Project: PROP - Parkside Neighborhood Center
& Affordable Housing
77 - 85 Grant Street

Addendum #5

**The Parkside Neighborhood Center
and Affordable Housing
Mellen & Grant Streets,
Portland, Maine 04101**

May 3,2004

CSK-2

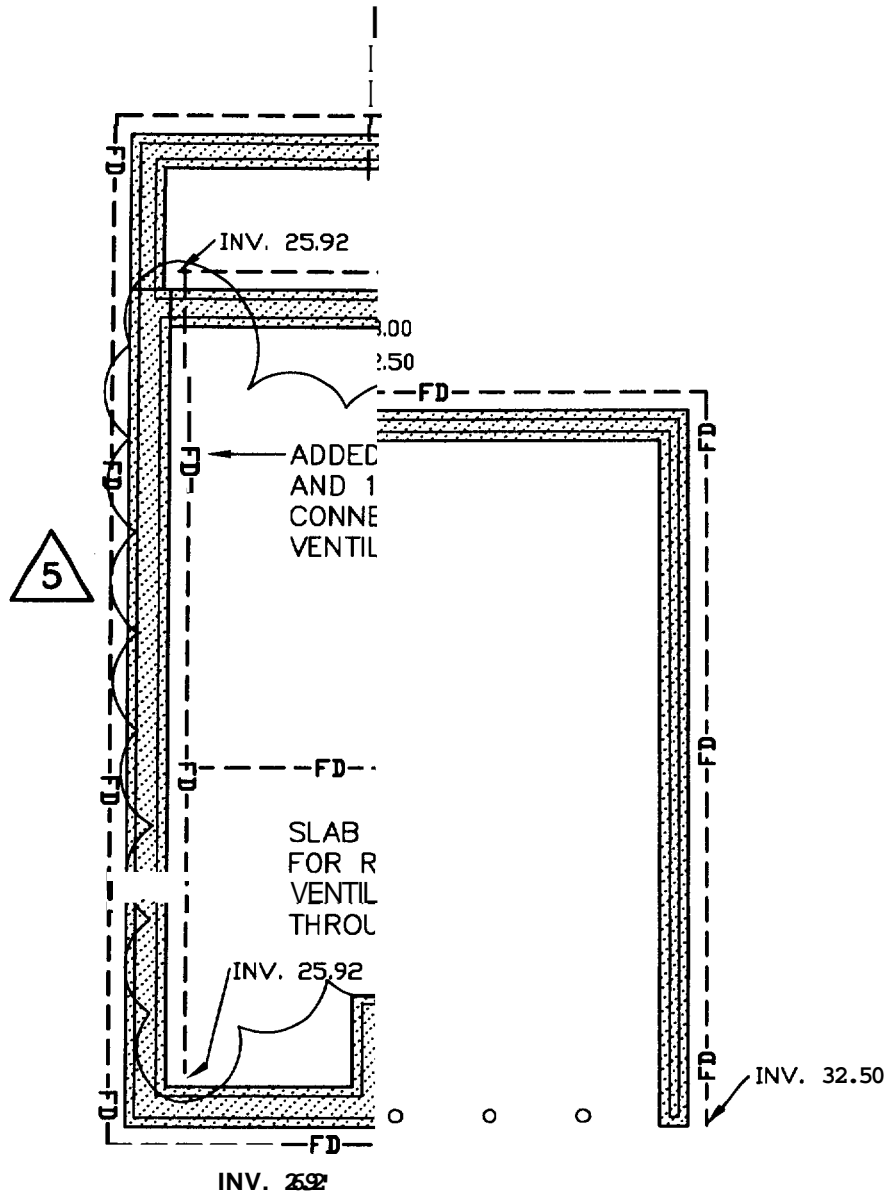
<u>Item</u>	<u>Bldg.</u>	<u>Sheet</u>	<u>Detail</u>	<u>Description</u>
<u>Civil</u>				
4-28	CSK-2	1		REVISE to add drain lines and cross connection for radon ventilation.
4-29	CSK-3	1		REVISE to add drain lines and cross connection for radon ventilation.
<u>Architectural</u>				
4-30	G1		Part. Types	REVISE to add sub type 1Ba, which adds a resilient channel on one side. REVISE type 1C to read 2 x6 studs matching wall sections. REVISE type 1D to read 2 x4 top and bottom plates not single 2 x6. ADD type 1E, 1 hr exterior, 1 side rated assembly. ADD type 1L, 1 hr roof/ceiling rated assembly. REVISE type 2E to shaftwall as indicated. ADD ‘2F’ label to shaftwall option to type 2C as indicated.
4-31	A-A1.O	1		DELETE Sheet C-7 from drawing list, dated 1/30/04. Add tempered glass note on Vestibule 014 side light glass.
	A-A1.O	1		DELETE chimney, revise as indicated.
4-32	A-A1.1	1		REVISE door number from Stair 108 to Lobby 109 to read 1092.
